**Zoning Board of Appeals
Regular Meeting**

March 12, 2026 - 6:30PM

MEMORANDUM

Memo Date:	March 6, 2026	Meeting Date:	March 12, 2026
Request:	Dimensional Variance	Applicant:	Kendra Scheerhorn
Address:	250 Mason Street	Zoning District:	R-4 CER
Parcel:	03-57-300-152-00	Recommendation:	See report
City Staff:	Grayson Moore	Consultant:	David M. Jirousek, AICP

250 MASON STREET SITE PLAN
3/1/2026

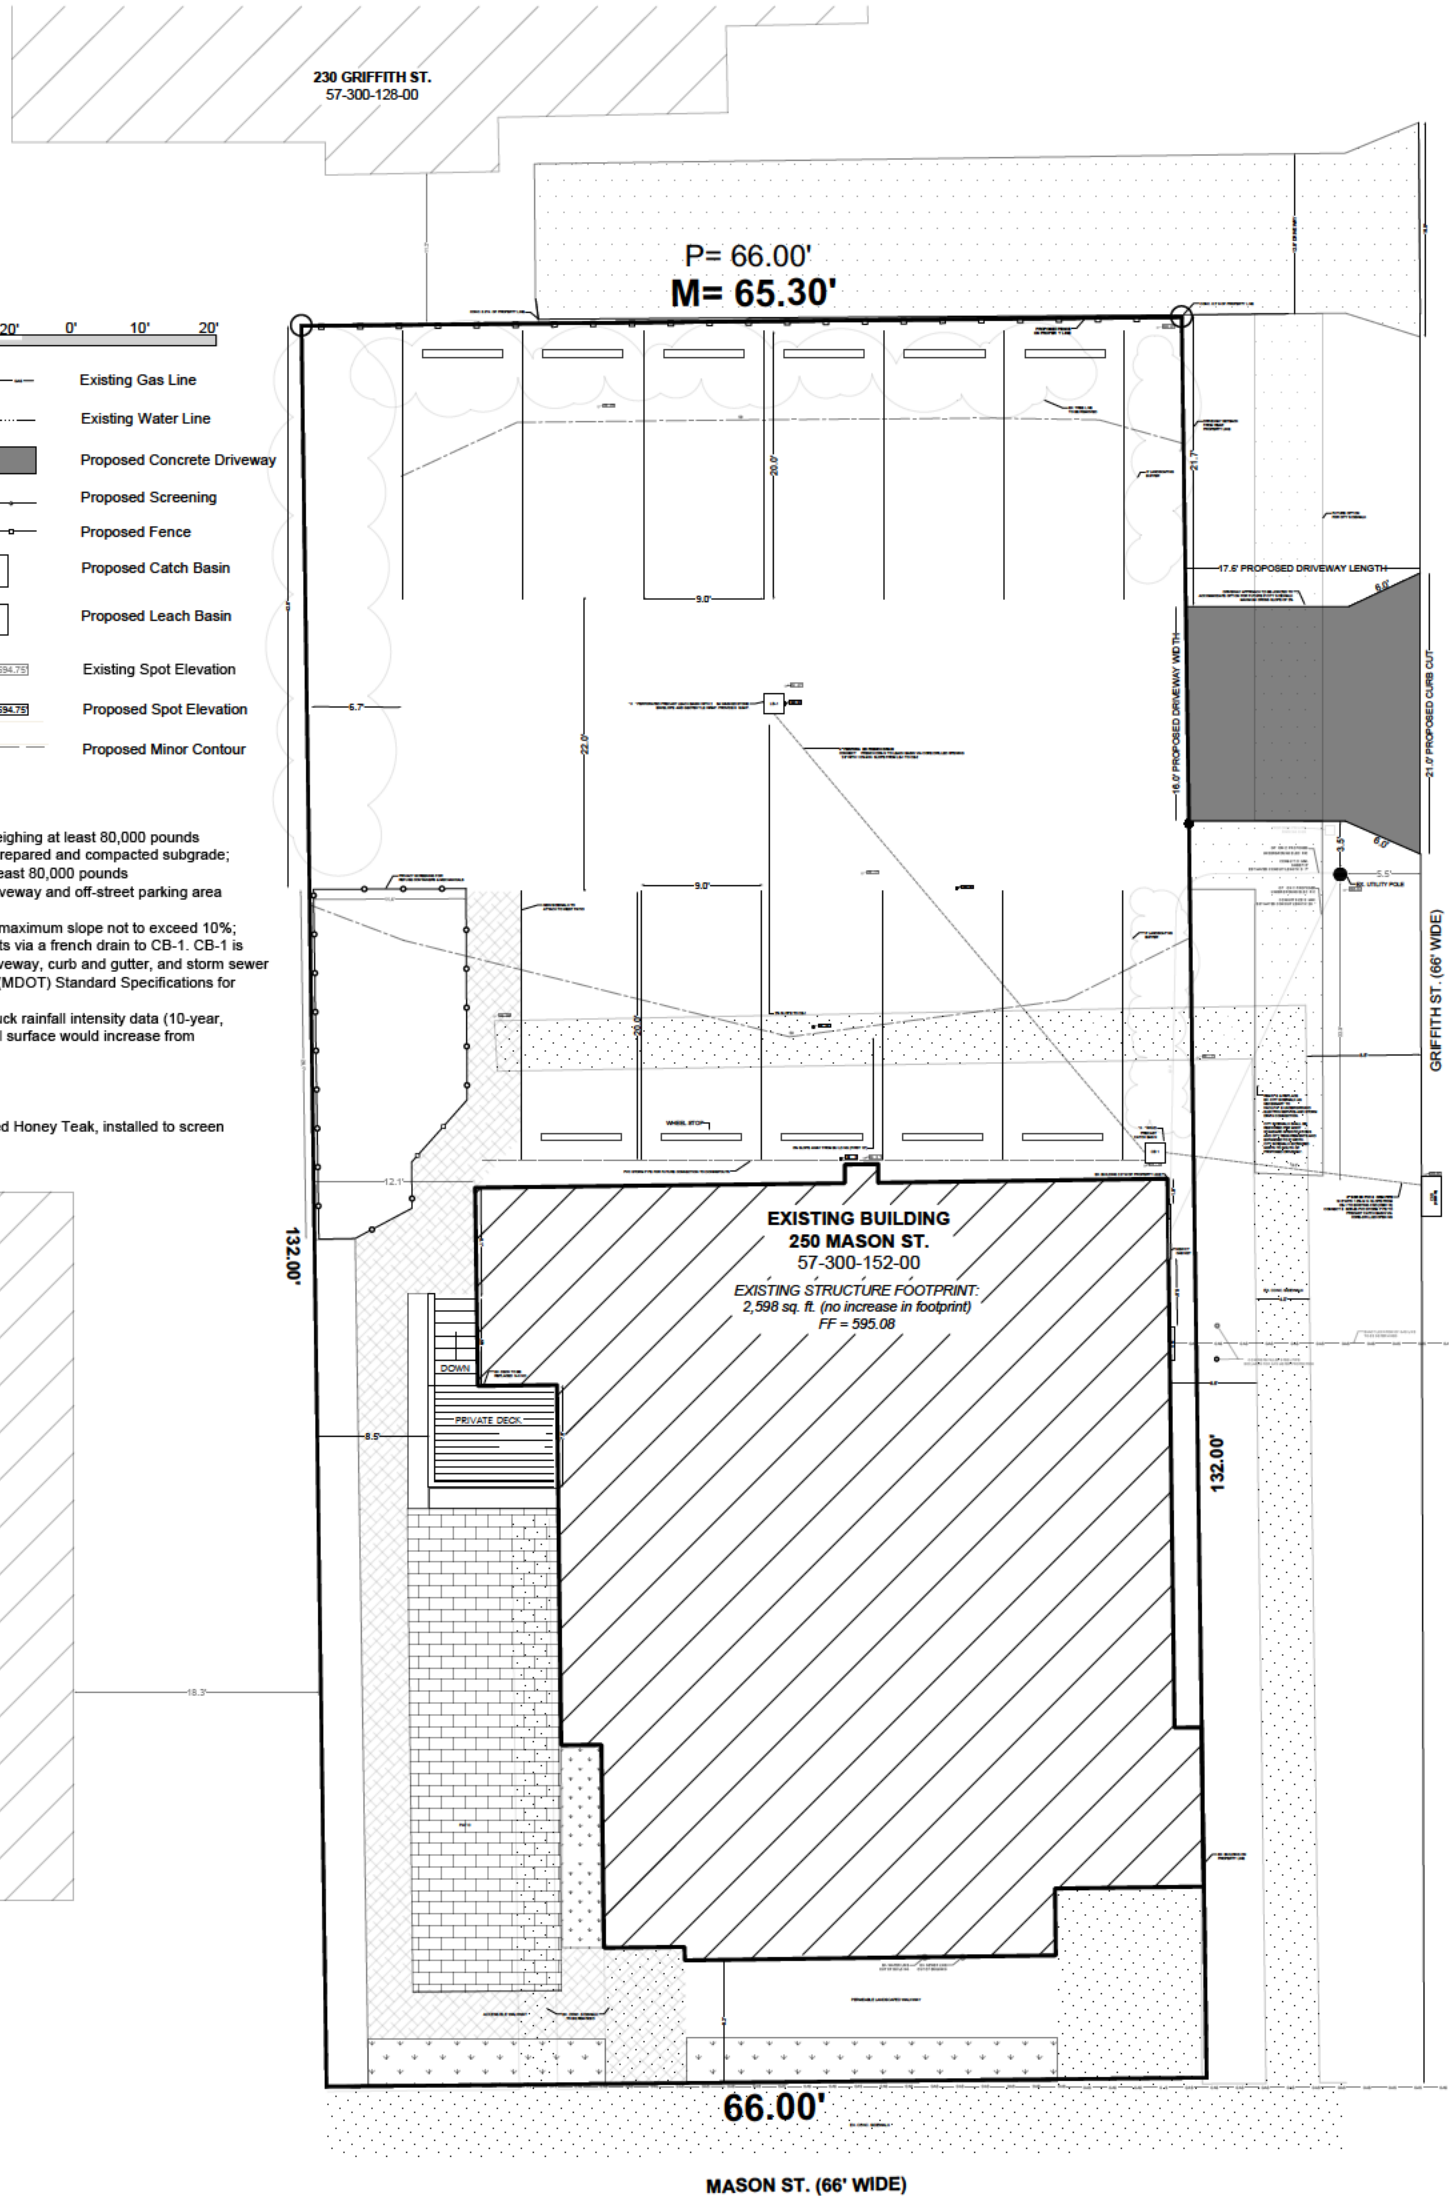
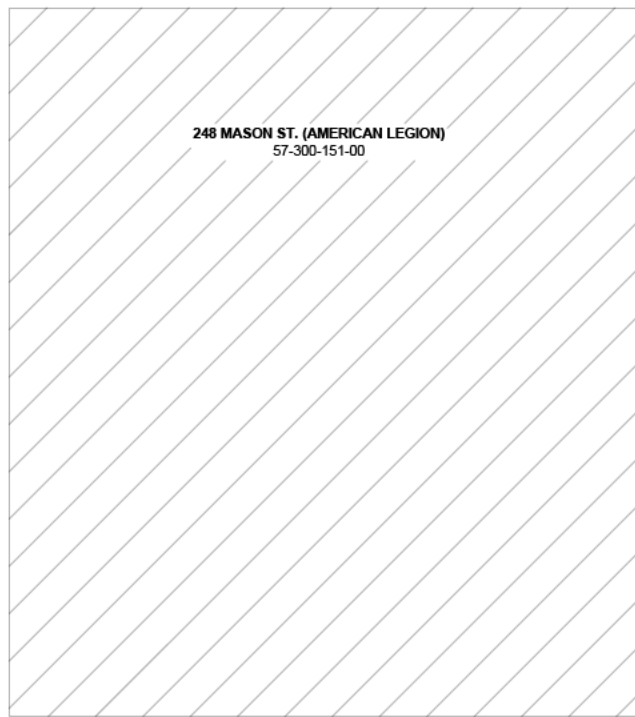
The Zoning Ordinance requires 90-degree parking spaces to be at least nine feet (9') wide and 20 feet deep, while drive aisles between parking rows must be at least 22 feet in width. The depth of the rear yard is approximately 62 to 63 feet, which would provide adequate space for the proposed 62-foot-deep, 11-space off-street parking lot.

While the dimension and size of the rear yard allow for an 11-space parking lot, there is insufficient space to incorporate the required five-foot (5') landscaping separation strip between the north parking row and the north (rear) property line. As such, the applicant seeks relief from this requirement and proposes a six-foot (6') high cedar board fence in place of the landscaped area.

It should be noted that the parking lot could be designed with nine-foot (9') wide parking spaces arranged in an "L-shape," with six (6) parking spaces along the rear of the building and four (4) parking spaces along the west property line, resulting in 10 spaces. The applicant should address whether alternative designs were considered and why compliance would be unnecessarily burdensome.

Comment: The applicant has not demonstrated that compliance with the Zoning Ordinance would be unnecessarily burdensome, as other development scenarios or a lesser number of parking spaces could be considered. The Zoning Ordinance only requires four (4) parking spaces for 10 guestrooms and an owner’s suite, which can be easily accommodated on the site, so compliance does not prevent the owner from using the property as a bed and breakfast. However, based on the City’s seasonal parking demands, it seems reasonable to accommodate all guest parking on-site and off-street, so compliance with the landscape strip and reducing the parking lot capacity could be considered unnecessarily burdensome.

Comment: A variance would allow the owner to reasonably accommodate all guests with on-site and off-street parking. Additionally, as long as stormwater runoff is managed, the larger parking area without the north landscape strip would do substantial justice to nearby property owners and residents, as the proposed six-foot (6’) fence would provide more substantial and effective screening of the parking lot than a landscape strip.
